DRAINAGE LETTER

HOPE PHYSICAL THERAPY

4850 Austin Bluffs Pkwy
Colorado Springs, CO 80918

DATE:
March 31, 2023

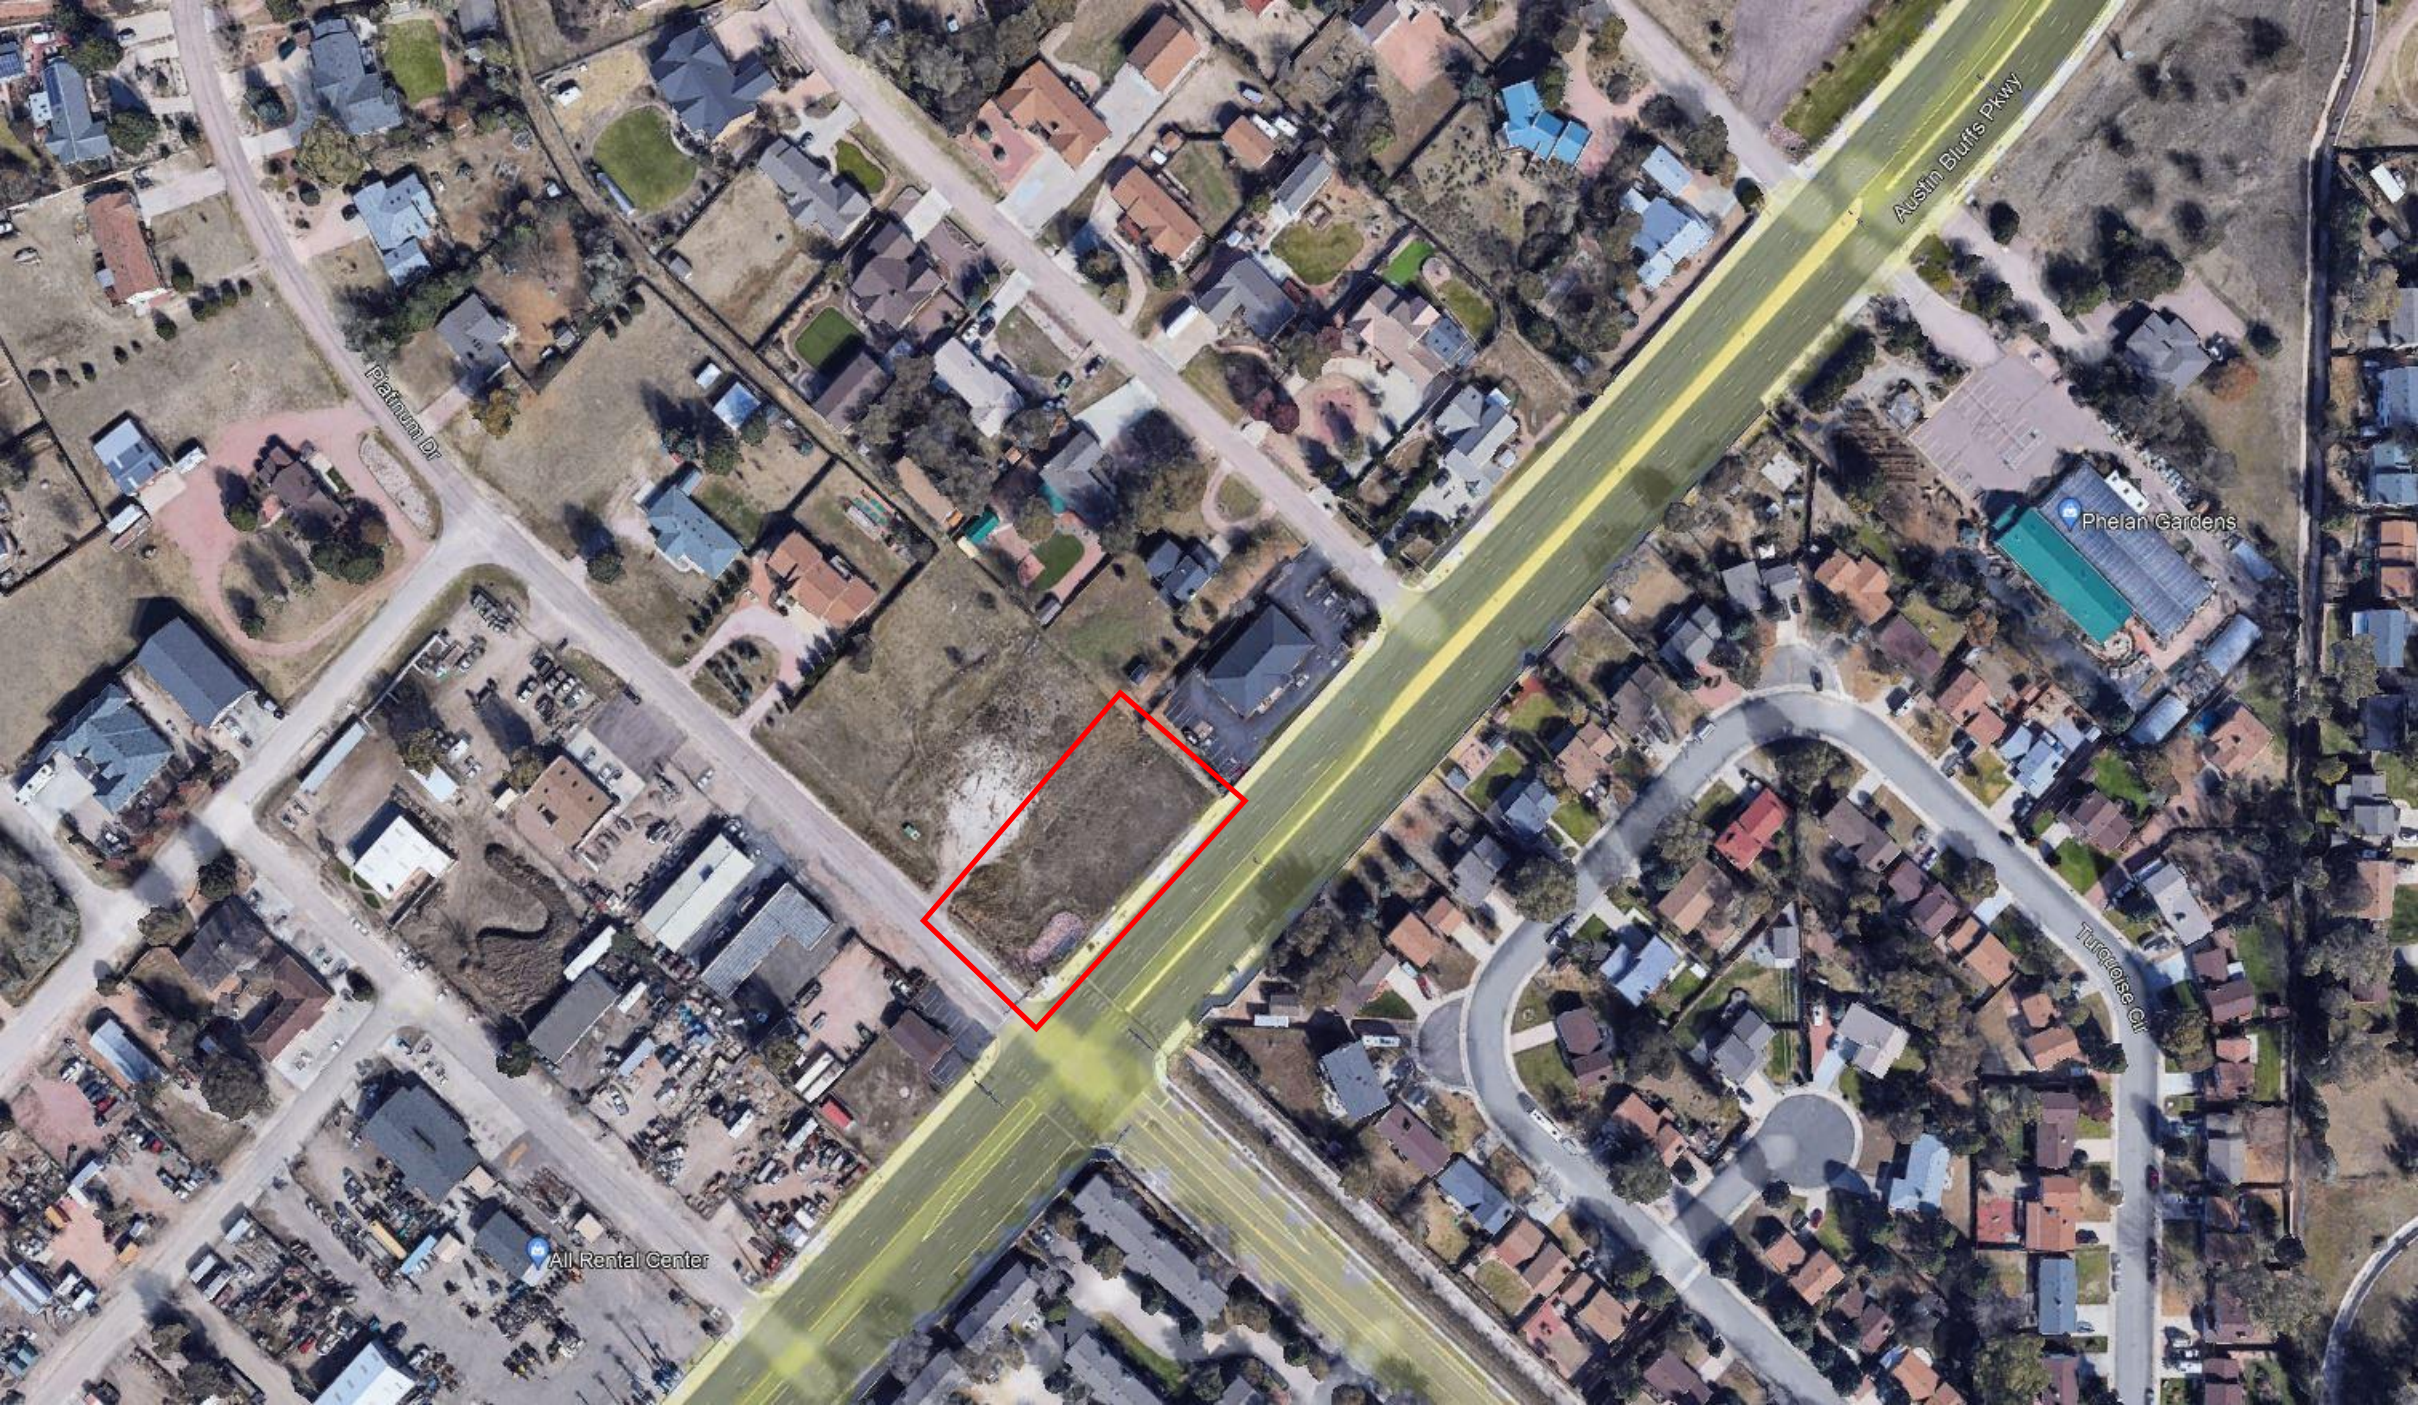
How are flows exiting existing pond? Is outfall still adequate with increased flows? Discuss where final outfall of flows are.

What are the existing flows exiting the site? State existing flows and compare them to the proposed conditions. State the difference in flows. Describe if the existing inlet is adequate to handle the increase in flows. Provide calculations.

Culvert Data: Culvert 1

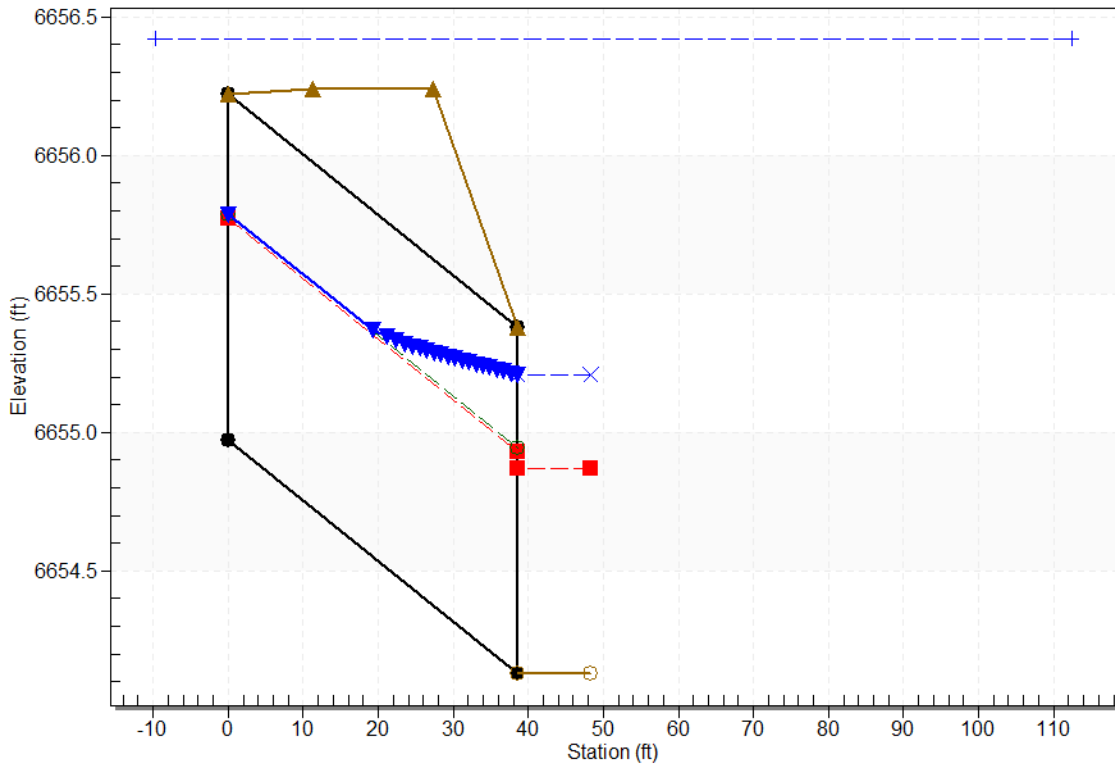
Min size culvert in ROW is 18" (ECM Section 3.3.2.C)

All pipes in ROW are to be RCP (ECM Section 3.3.1.J.1)

Provide slope and velocity
